CR262 – Passenger Backrest Inspection

XDiavel Model Year 2016-2023 (all versions)

Safety Recall Campaign SRV-RCL-23-005

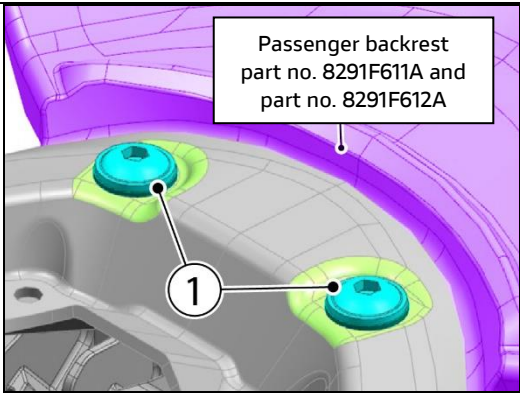
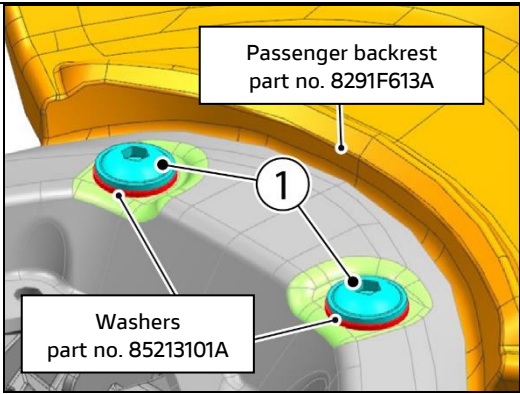
2. Remove passenger seat.
3. Remove the passenger backrest by first removing the 2 lower fixing screws and then the 2 upper fixing screws.
4. Carry out a visual check of the backrest, focusing particularly on the areas adjacent to the 4 fixing holes (see photo with examples of possible cracks)

- a. If the passenger backrest is undamaged (no cracks and/or breaks), the backrest can be reinstalled.
- b. If the backrest shows cracks and/or breaks, the passenger backrest must be replaced with a new one ordered from the spare parts warehouse.

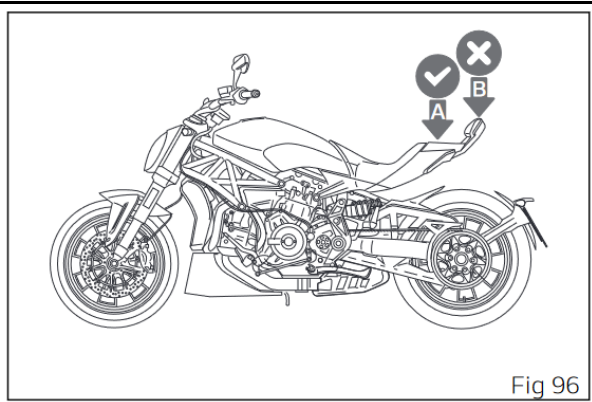
6. Thoroughly clean the surface of the backrest and apply the **warning sticker** part no. **43315251A** exactly at the point indicated in the figure.
